**Chevy Chase Village
Board of Managers**

**APPEAL NUMBER A-6895—CONTINUED
MR. CHRISTOPHER IAN AND MS. VICTORIA TWINN
OF 5503 CENTER STREET &
MR. DAVID AND MS. JULIA LEE
OF 5505 CENTER STREET
CHEVY CHASE, MARYLAND 20815**

ADDENDUM TO REPORT DATED OCTOBER 14, 2016

DRAINAGE REPORT FOR 5502 GROVE STREET IN CHEVY CHASE, MARYLAND

Aerial Photo from MCAtlas website. Lot Numbers in red. Photo taken prior to construction. Subject Property is Lot 26.

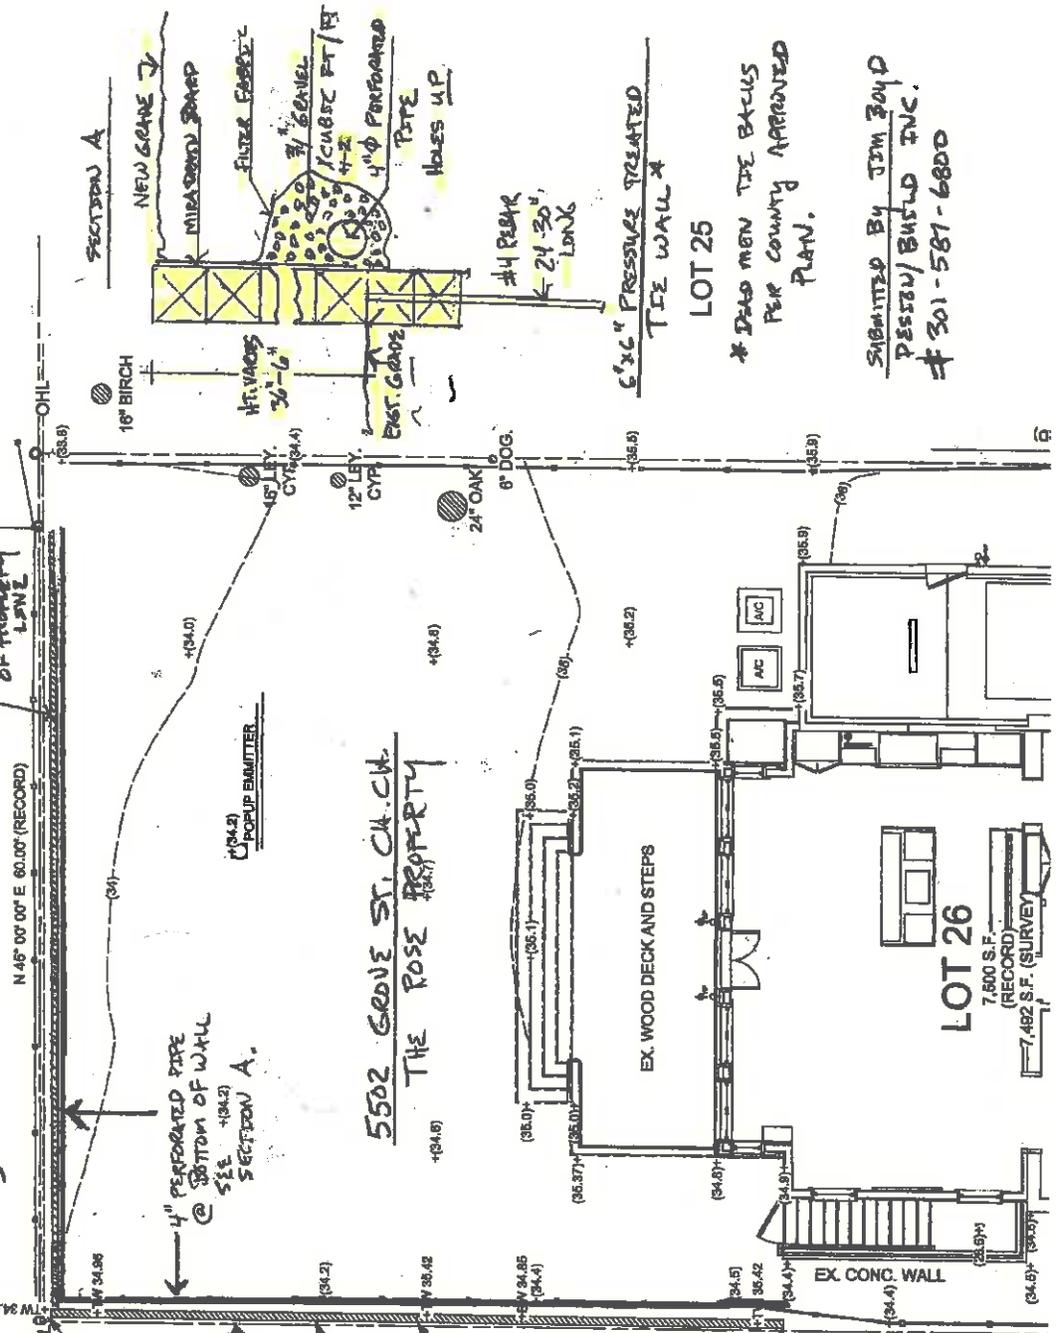
Based on the plans provided to us, the pre-construction storm water runoff for the subject property (Lot 26) drained from the front right to the rear left of the property. (All references to locations on a property such as front, back, right and left are based on a person standing in the street in front of the noted property and looking at the house.) This drainage pattern also directs water from the adjacent properties at 5504 and 5506 Grove Street to both the subject property and to 5503 Center Street, as can be seen on GIS topographic data available for Montgomery County.

The grading on the subject property disrupted the previous drainage pattern and caused runoff from the house to flow to the rear right of the property instead of to the rear left of the property. Runoff from the adjacent uphill properties is similarly effected and is directed to the rear right of the subject property from where it is conveyed around the retaining wall. Runoff that was previously entering as sheet flow towards the rear of the property at 5503 Center Street is now being concentrated by the construction of the new wall and the concentrated water flows from the up stream end of the wall and traverses the property at 5503 Center Street.

SUBMITTED BY JIM BOYD
PESSEN/BUILD INC.
301-581-6800

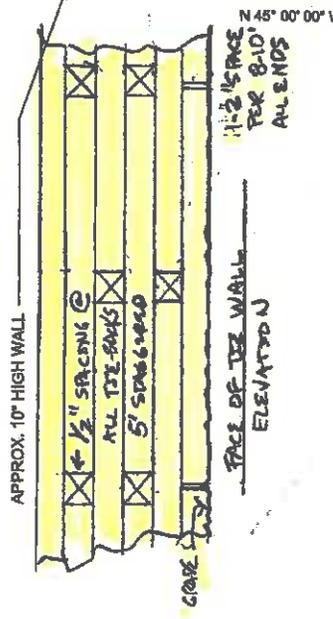
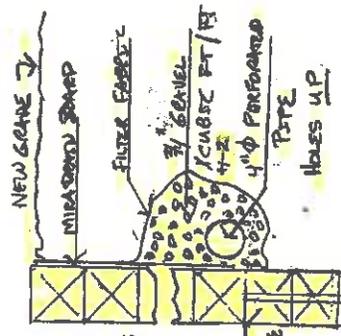
Catch Basin: Placing the catch basin 10' to the right of the outside edge of the retaining wall is preferable to the current design. According to Mr. Twinn's observation, having the water flow out of the wall at this location should more closely resemble the pre-existing flow path of the runoff. This would also reduce the amount of grading on the Rose's property since the catch basin would be moved upgrade from its existing location. We do not believe that this would cause additional adverse impact to the adjoining property. Our concern is conveying the runoff, not storing it.

In order to reduce the likelihood that the catch basin would clog, a dome cover should be used. If this is not available for a 6" catch basin, a 9" catch basin should be used. Based on our site visit, it also appears that the distance of 10' to the right of the outside edge of the retaining wall may not ensure that water bypasses the catch basin on the Twinn's property. If the Twinn's and Rose's are in agreement, we recommend that the location of the catch basin be moved 12' to the right of the outside edge of the retaining wall. We were able to find a 9" catch basin with a domed cover on line at <https://drainagekits.com>.

We are not opposed to a suggestion made by Mr. Samos that a larger pipe (6" instead of 4") be used to convey the water from the catch basin to the gravel drain tile. We do not think that this will substantially change the intent of our design, and the cost difference should not be substantial. Ultimately, the catch basin in Mr. Twinn's yard is limited by the pipe capacity of the 3" pipe that conveys that water to the street.

Conveyance of Overflow: There is a concern that a clogged grate, pipe or gravel drain will back up water in the proposed swale. The back up would force water to the rear right of the Rose's property before flowing to the Twinn's property. We proposed at the meeting that ½ " weep holes be drilled into the top tier of the timber wall, spaced at 2' on center, at the midpoint of the timber. As the length of the wall is approximately 55', that would allow for 26 weep holes. This would allow for the passage of additional flow in the case that the water backs up in the Rose's property.

Additional observation from field visit. It is possible that the drain tile and the Miradrain Board used by the contractor is to dewater the area behind the retaining wall and direct the flow to the rear right of the subject property (to the terminus of the retaining wall). When completing these changes, the contractor should ensure that the perforated pipe and the drain tile do not outfall at the terminus of the retaining wall as this would contradict to the intention of the plan revision. Thus the perforated pipe should be capped, and the gravel removed for the final 5' of the retaining wall. Additionally, ½" weep holes should be drilled into the bottom two tiers of timbers at 2' on center on each timber. When drilling the weep holes, the drill should pierce the Mira Drain fabric to ensure that water will be able to pass through the it and the weep holes. Also, at areas were there is a gap in the timbers, the fabric should also be pierced to encourage passing of the water. A meeting with the contractor would be helpful.
